From: [Paul Nietfeld](#)
To: [Benton County Talks Trash](#)
Cc: samimperati@icmresolutions.com
Subject: Citizen input for Workgroup meeting Sep. 15
Date: Monday, September 12, 2022 9:26:01 PM
Attachments: [Nietfeld comment input Workgoup Meeting2_15Sep2022.pdf](#)

Coffin Butte: Intake Volume History

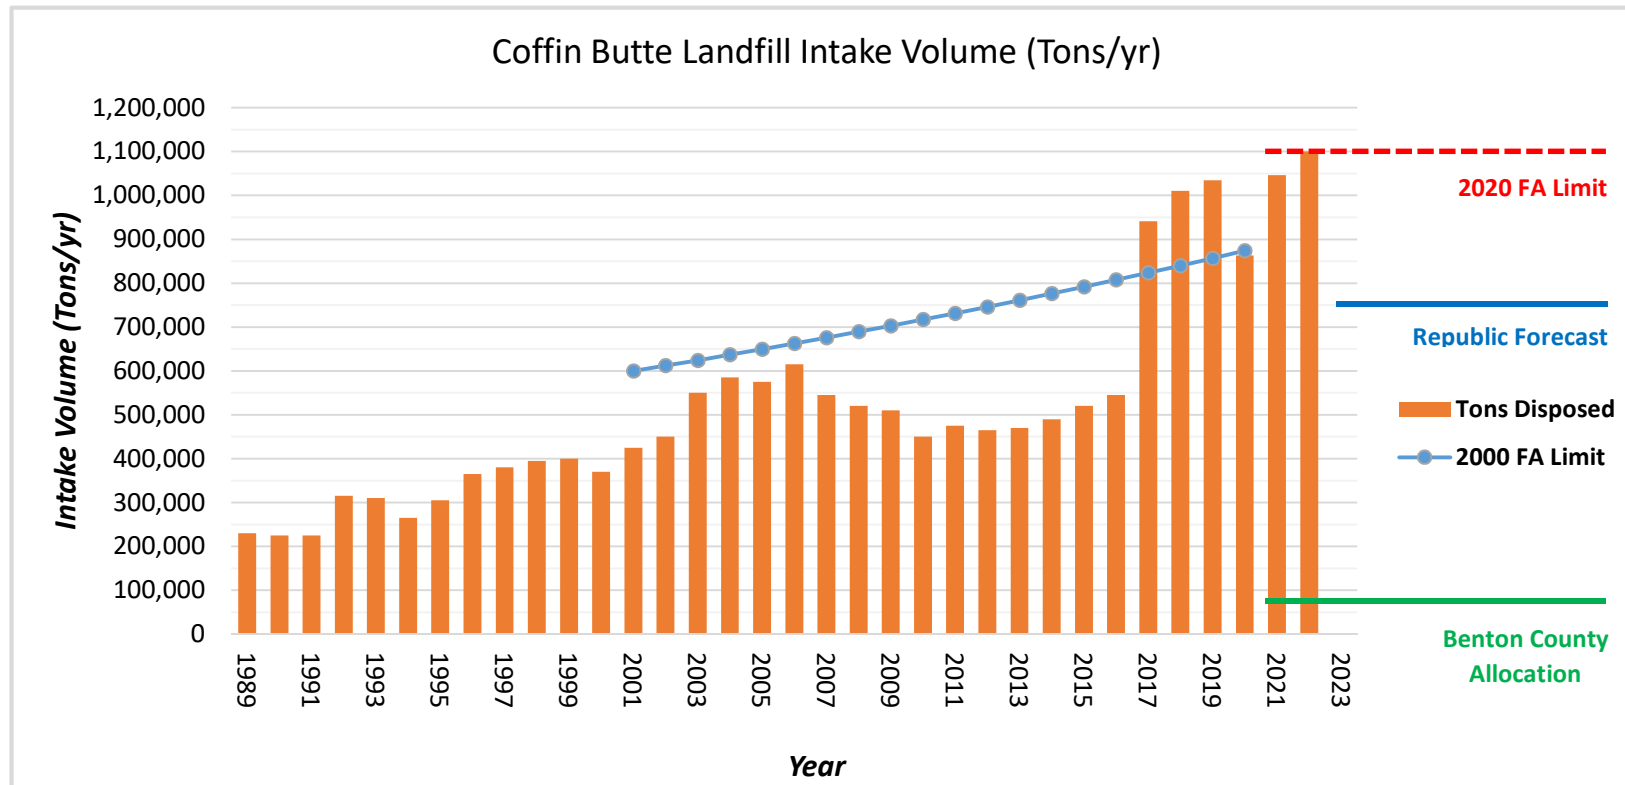
- Large-scale industrial operation: 1.1 M Tons/year => 7,000,000 lbs/day, 6 days/week
- Dramatic growth starting in 2017 – *What happened to cause and sustain this?*
- The 2000 Franchise Agreement intake limit was violated in years 2017–2019 – *Why no County action?*
- 2022 volume is estimated from first half 2022 filings with DEQ.
- Recent years show sustained high demand for landfill volume – *Does Republic plan to maintain this level?*
- Even a 5,000,000 cubic yard expansion cell would fill in less than 5 years at the current intake rate

This plot shows why we (workgroup, staff, administration, the public and the franchisee) are here: Large intake volume in the last 6 years is quickly depleting the available Cell 5 volume.
